Taif farm – north zone, FINAL site baseline v2, 03 Oct 2026

Driveway on the straight M line from the gate east post (G′ = M1). Field check of 03 Oct: 44 tapes, least-squares fit. Concept baseline – not for permit.

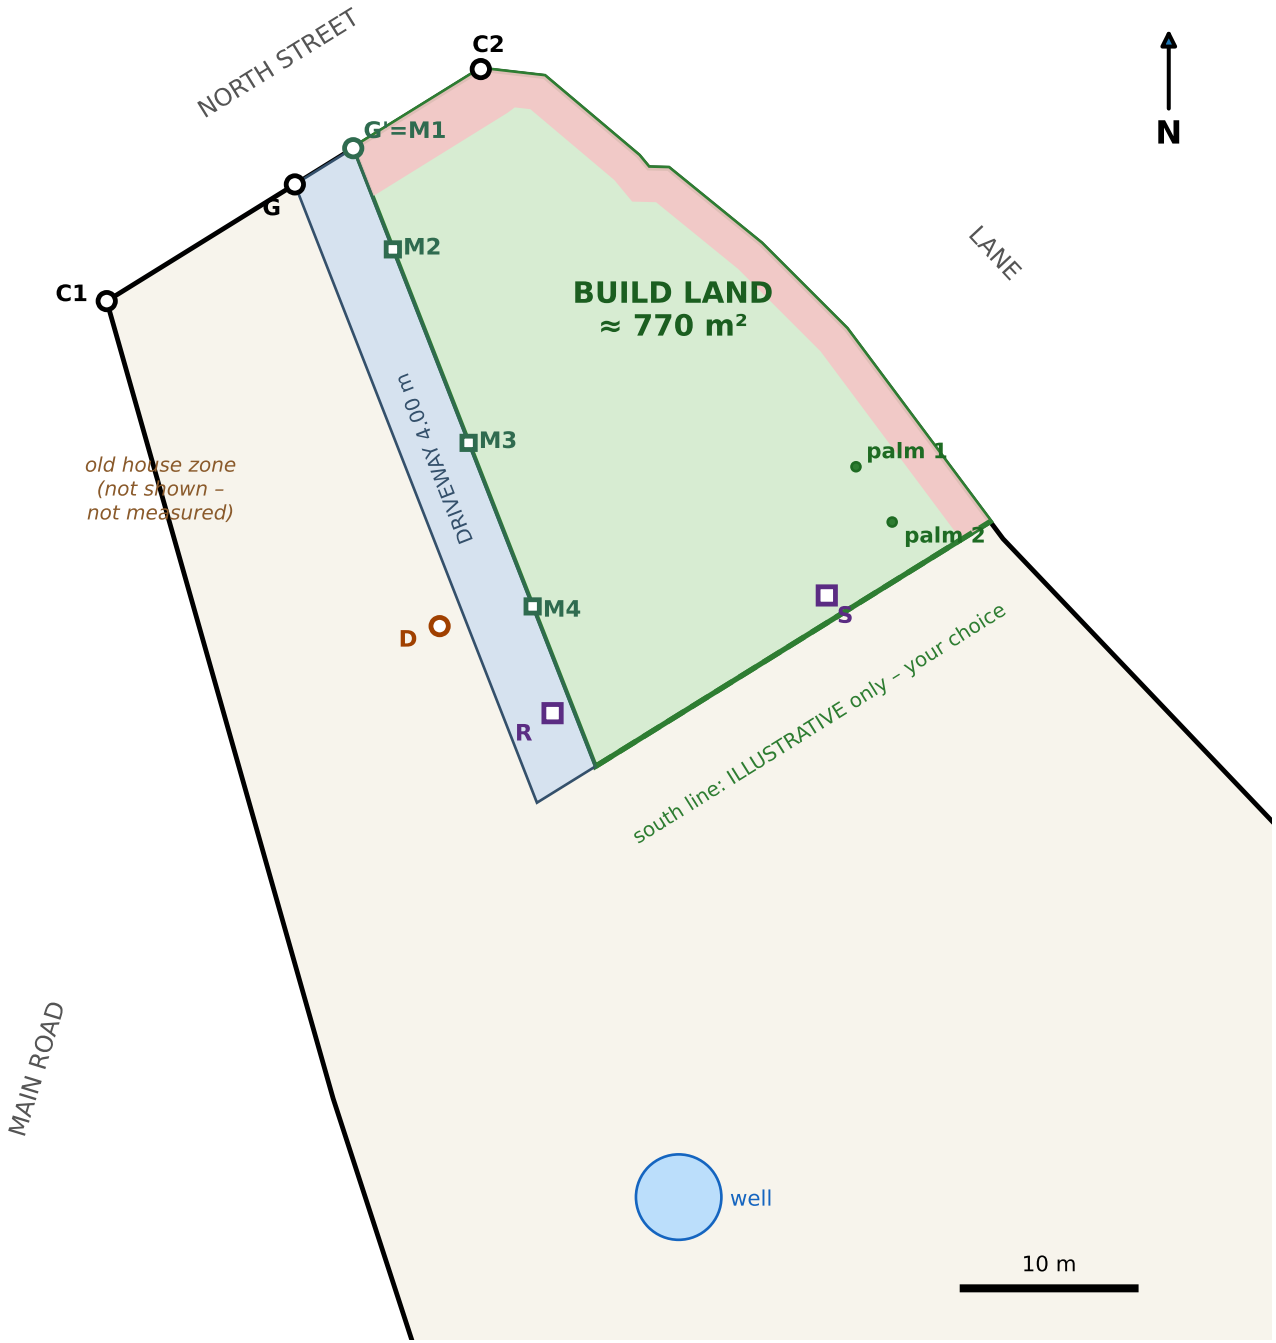
WARNING – v1 driveway direction was wrong

v1 drew the driveway square to the north wall (88° ± 3°) from the old G′→D tape "28 m" with no centimetres. The new tapes (G′→D 28.41, M4→D 5.60, G→D 27.30) and the whole east-wall network give ≈ 100°. A square driveway is geometrically impossible with these readings. v2 replaces v1.

Item	v1	v2
Driveway angle to the north wall	≈ 88°	≈ 100°
Build land (illustrative south line)	≈ 596 m²	≈ 774 m²
Buildable envelope after setbacks	≈ 494 m²	≈ 668 m²
Palms along the lane wall	±1–2 m	≈ 1.9 m further SE, ±0.3 m
Lane wall = deed line?	assumed	checked, ±0.4 m

D1 Driveway = the straight M line from the gate east post: east edge on M1–M4, west edge parallel through the gate west post (4.00 m gate, ≈ 3.95 m clear square to the line).

D2 Setbacks 3 m from the north street, 2 m from the lane (confirm with Balady / the engineering office).

D3 Old house and carport not shown (not measured, outside the build land). South line: open – drawn illustratively.
